Wednesday, January 19, 2022
Development Review Committee

Re: Ordinance Construction Standards Revision

AN ORDINANCE AUTHORIZING AMENDMENTS TO THE CONSTRUCTION STANDARDS OF THE CITY

CONSTRUCTION STANDARDS

(801) 804-4550
STANDARD DRAWING
2" WATER SERVICE
DRAWN: JLR
DESIGN: MHC
REVISION:
DATE: 4/16/2019
SCALE NONE
STANDARD W-214

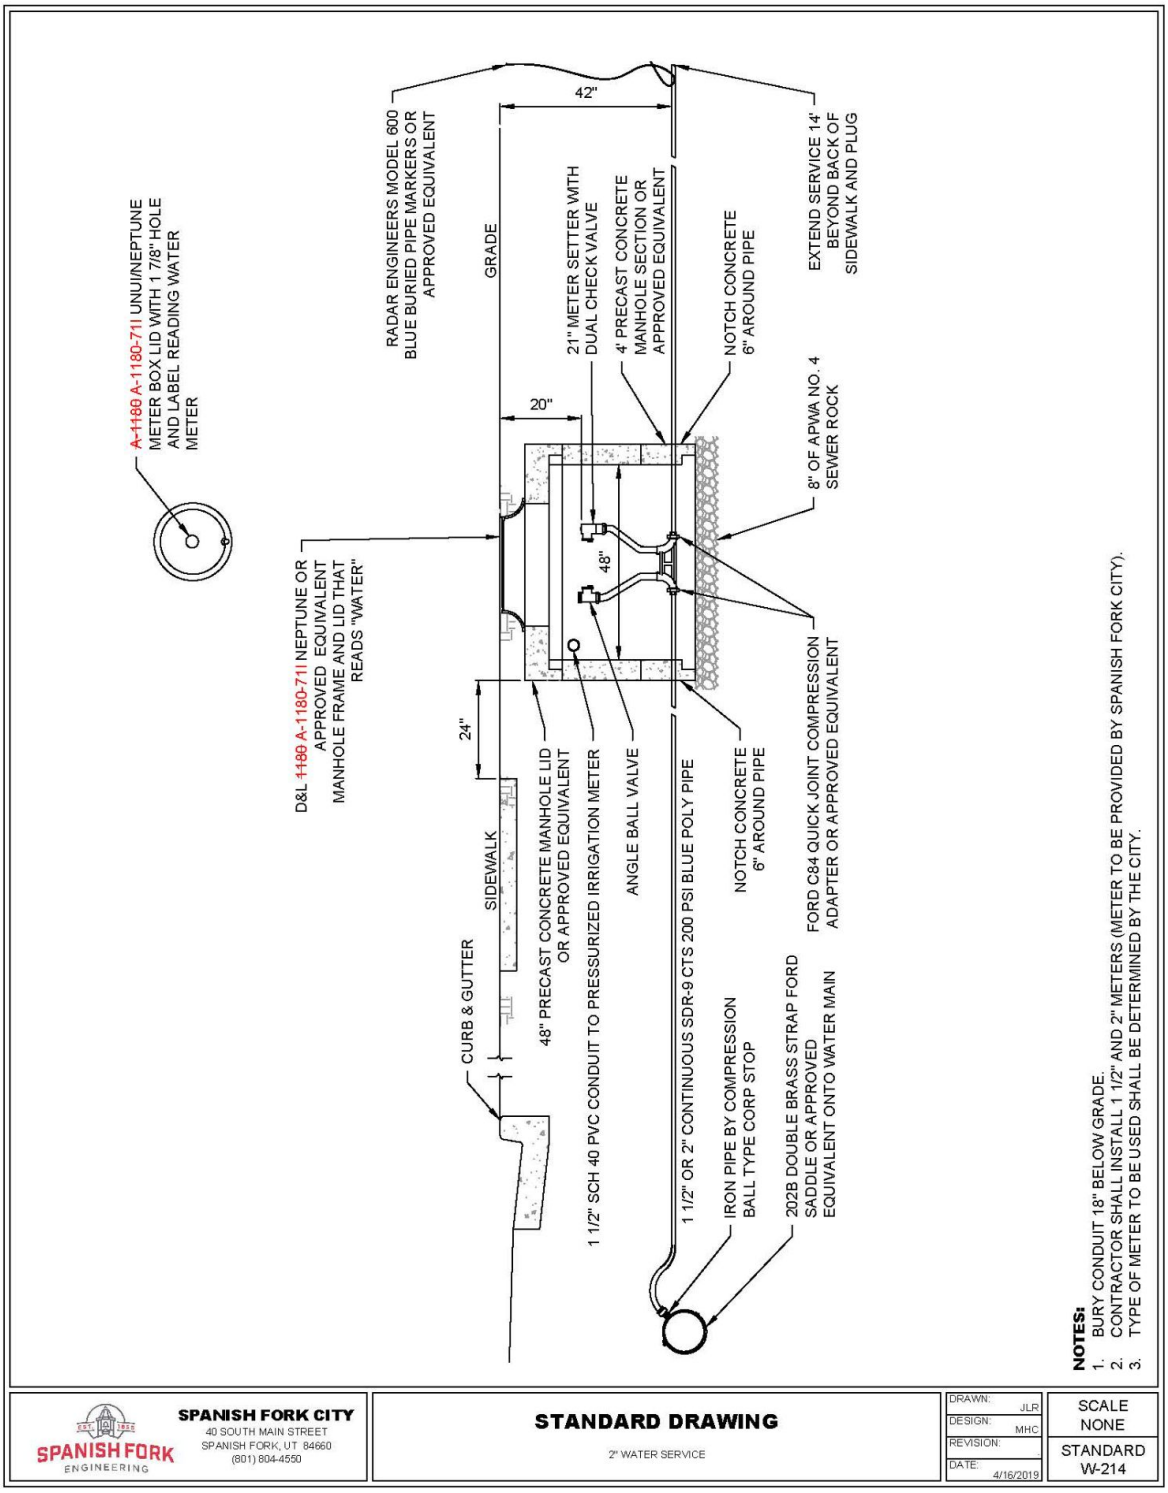
- Modifies standards W-214, W-215, W-218, W-219 & W-222 to call out the correct manhole lid.
- Adds Private Sleeves, Casings, and or Carrier Piping note.
- Modifies Concrete Collar to read ⅛" (max) instead of ¼"

A-1180 A-1180-711 UNUI/NEPTUNE METER BOX LID WITH 1 7/8" HOLE AND LABEL READING WATER METER
D&L 1180 A-1180-711 NEPTUNE OR APPROVED EQUIVALENT MANHOLE FRAME AND LID THAT READS "WATER"
RADAR ENGINEERS MODEL 600 BLUE BURIED PIPE MARKERS OR APPROVED EQUIVALENT
42"
GRADE
20"
21" METER SETTER WITH DUAL CHECK VALVE
4' PRECAST CONCRETE MANHOLE SECTION OR APPROVED EQUIVALENT
NOTCH CONCRETE 6" AROUND PIPE
EXTEND SERVICE 14" BEYOND BACK OF SIDEWALK AND PLUG
8" OF APWA NO. 4 SEWER ROCK
48"
24"
CURB & GUTTER
SIDEWALK
48" PRECAST CONCRETE MANHOLE LID OR APPROVED EQUIVALENT
1 1/2" SCH 40 PVC CONDUIT TO PRESSURIZED IRRIGATION METER
ANGLE BALL VALVE
NOTCH CONCRETE 6" AROUND PIPE
FORD C84 QUICK JOINT COMPRESSION ADAPTER OR APPROVED EQUIVALENT
1 1/2" OR 2" CONTINUOUS SDR-9 CTS 200 PSI BLUE POLY PIPE
IRON PIPE BY COMPRESSION BALL TYPE CORP STOP
202B DOUBLE BRASS STRAP FORD SADDLE OR APPROVED EQUIVALENT ONTO WATER MAIN
NOTES:
